PREVOST

**WARRANTY
 BULLETIN**

Wb06-08

DATE : OCTOBER 2006	SECTION : 06 - Electrical
EXPIRATION: OCTOBER 2008	
SUBJECT : REPLACING 24-VOLT RELAYS IN THE REAR JUNCTION BOX

FIGURE 1 : REAR JUNCTION BOX ON COACHES

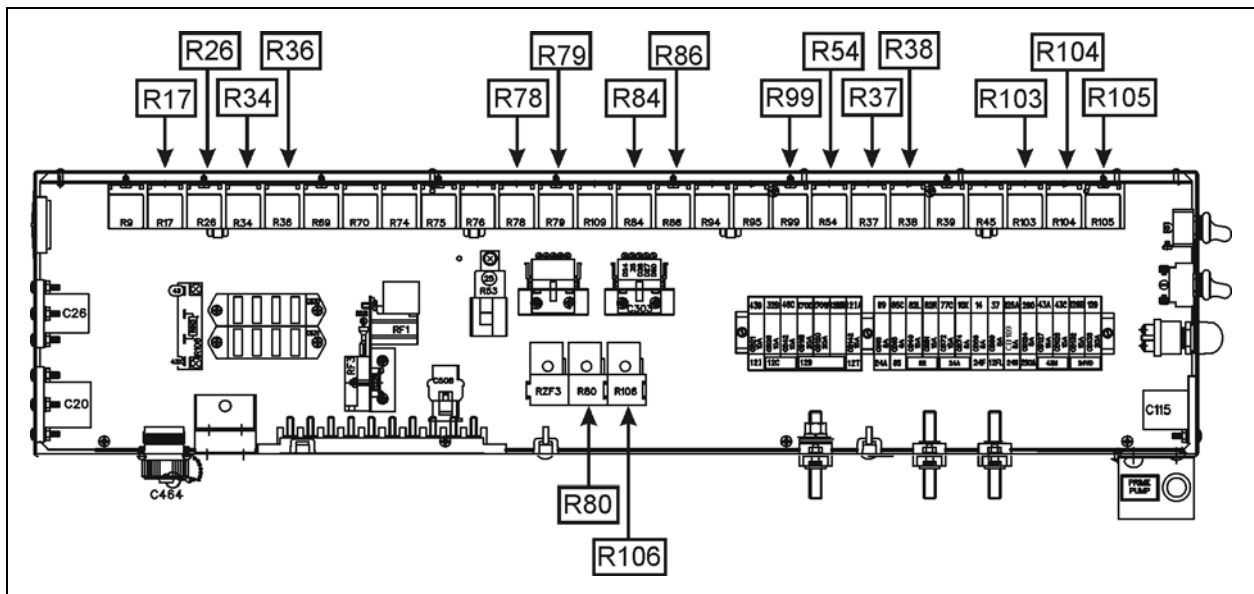
1. Inside engine compartment, open the rear junction box access panel.
2. On coaches, replace the relays identified on figure 1. On Entertainer's, replace the relays identified on figure 2.

If the relays are kept, it is very important not to use them as replacement parts for the following relays: R17, R26, R34, R36, R37, R38, R54, R78, R79, R80, R84, R86, R99, R103, R104, R105, R106.

FIGURE 2 : REAR JUNCTION BOX ON ENTERTAINER TYPE VEHICLES

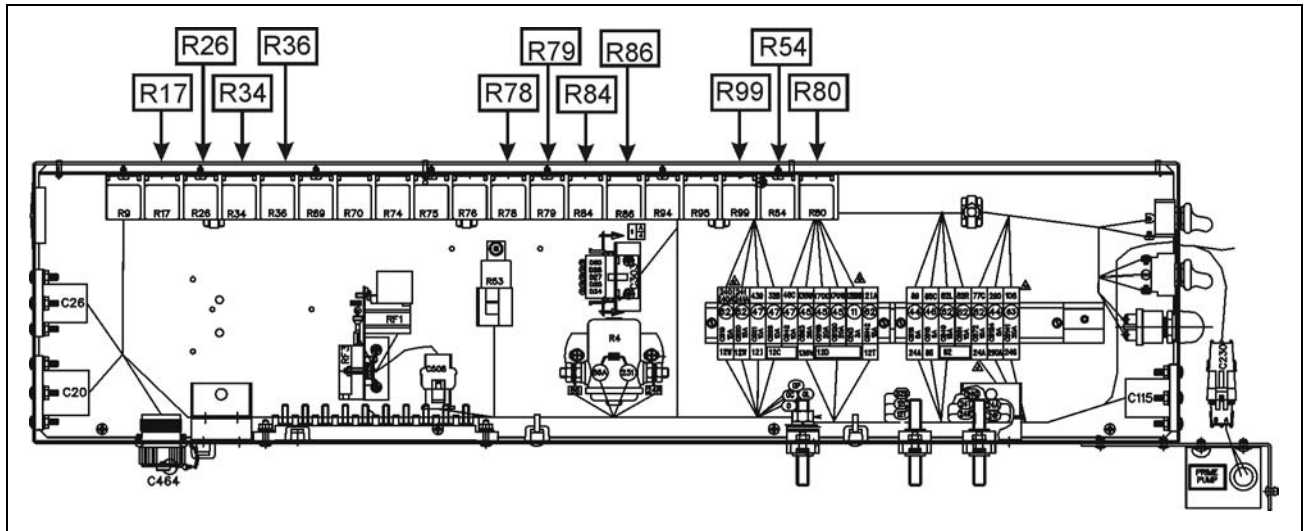
If the relays are kept, it is very important not to use them as replacement parts for the following relays: R17, R26, R34, R36, R54, R78, R79, R80, R84, R86, R99,
